Rezoning Transportation Analysis

Petition Number: #2022-048

From: Jake Carpenter, PE
Jacob.Carpenter@charlottenc.gov
980-221-5675

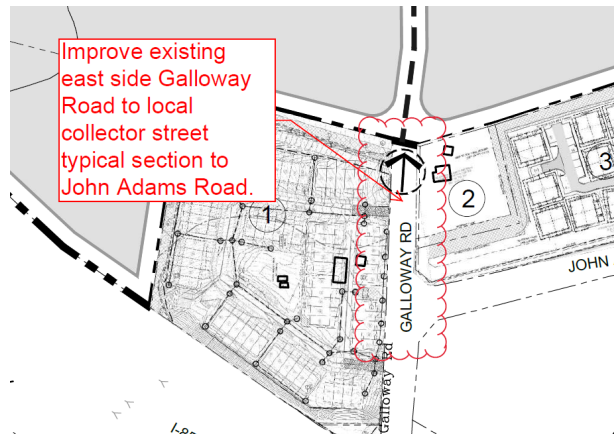
Updated Comment 04-25-23: Revise site plan conditional notes to include the following improvements from the approved TIS:

- The Mallard Creek Church Road and Mallard Glen Drive intersection improvements need to have two separate improvements with regards to the southbound left turn lane as shown below:

- “Provide a southbound left turn lane on Mallard Glen Drive with 150 feet of storage and appropriate deceleration/taper before the first CO.” This improvement would be tied prior to the first CO.

- “Provide a second southbound left turn lane on Mallard Glen Drive with 150 feet of storage and appropriate deceleration/taper prior to 401st residential CO.” The improvement would be tied prior to the 401st CO.

- The Mallard Glen Drive and Mallard Highlands Drive intersection improvement needs to be updated to being tied prior to 401st CO. Second receiving lane on Mallard Glen Drive is not needed initially.

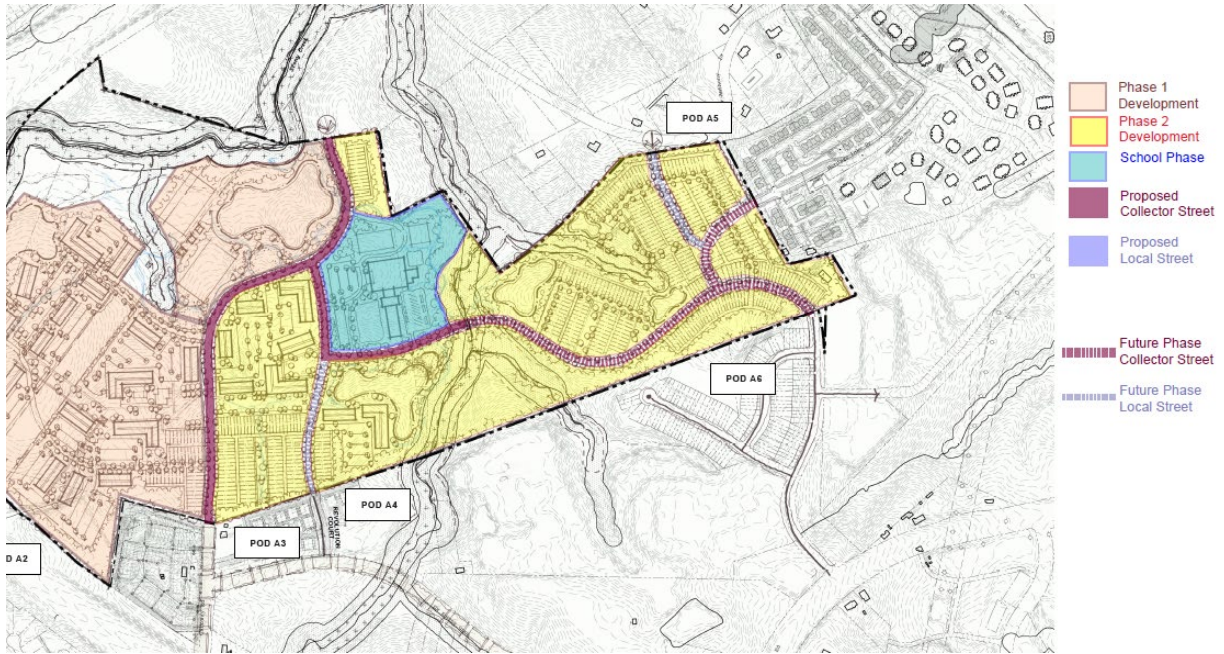
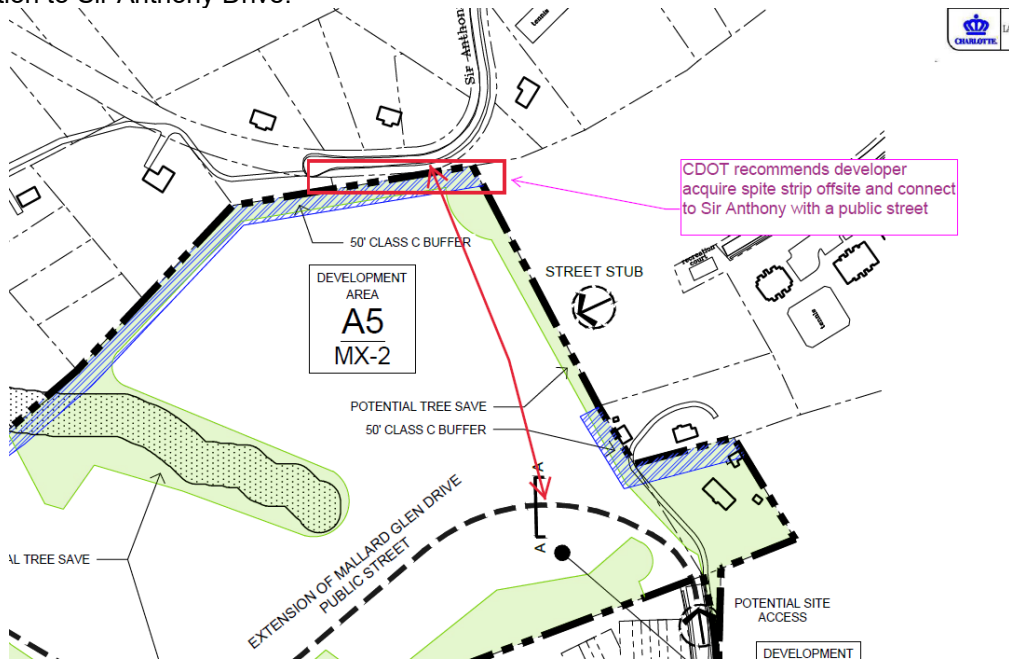
3. ~~Outstanding Comment from 08-25-22:~~ Revise site plan and conditional note(s) to commit to improving the existing Galloway Road stub to John Adams to the local collector street typical section per U-07.

4. ~~Revise site plan and conditional note(s) to commit to the proposed roadway network typical sections and proposed phasing outlined in the Traffic Impact Study. Provide typical sections per CLDSM for all proposed public and private streets. Provide 8-foot sidewalk and 8-foot planting strip on all public streets.~~
